Amendment to the Drawings:

Four (4) Replacement Sheets with four (4) corresponding Annotated Sheets showing the amendments to Figs. 1, 2, 3, and 5 of the drawings are enclosed.

REMARKS

Fig. 1

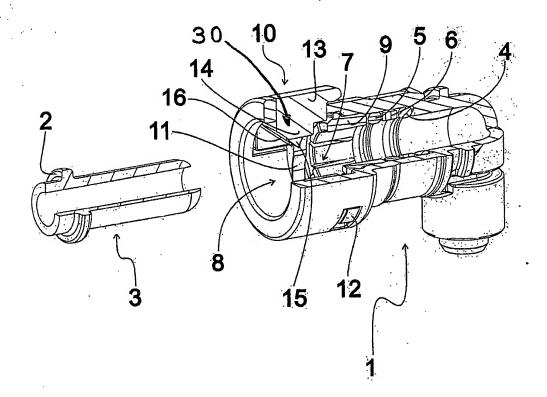
Responsive to the Examiner's objection regarding the drawings, Applicants have amended Figs. 1-3 and 5 to designate the prelock assembly as "30" and to designate the pullback assembly as "31." Responsive to the Examiner's related objection regarding the specification, Applicants have amended paragraph [0017] of the specification as originally filed to use numeral 31 in connection with the pullback assembly.

Referring Figs. 1 and 3 of the present application, the claimed conduit coupling includes locking element 10 movable into receiving space 7 of receiver 1, with locking element 10 including transverse portion 13 (Fig. 3) and a pair of arms 11 and 12 extending from opposite ends of transverse portion 13, together with a prelock assembly including a retaining portion 14 formed on transverse portion 13 of the locking element 10, and retaining portion 14 engaging retaining ring 2 of insert 3 to prevent insert 3 from being pulled out of receiver 1.

New dependent Claim 10 further calls for the locking member to be immovable along the insertion direction. Referring to Fig. 1 of the present application, it may be seen that locking element 10 is immovable along the insertion direction, i.e., along an axial direction of receiver 1, but rather is only movable in a radial direction with respect to receiver 1, *i.e.*, between the raised position, the push-end position, and the prelocked position. By contrast, in the assembly of Washizu '467, the confirmative member 8 is axially movable with respect to joint body 2.

Fig. 3

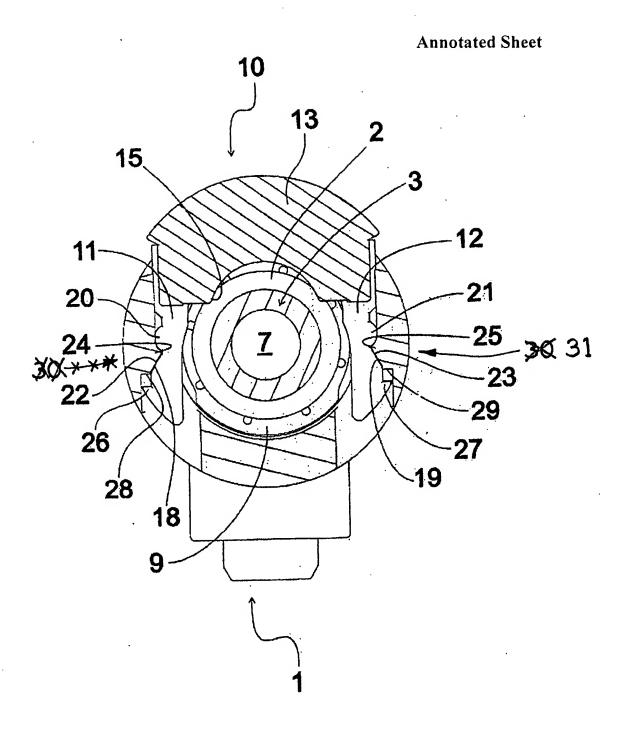
Referring to Fig. 3 of the present application, pullback assembly 31 includes second beveled surfaces 18 and 19 respectively disposed on arms 11 and 12 of locking element 10, which are associated with third beveled surfaces 22 and 23 of receiver 1, the second and third beveled surfaces cooperating to generate a force in a direction opposite to the direction of movement of locking element 10 from a prelocked position to a raised position
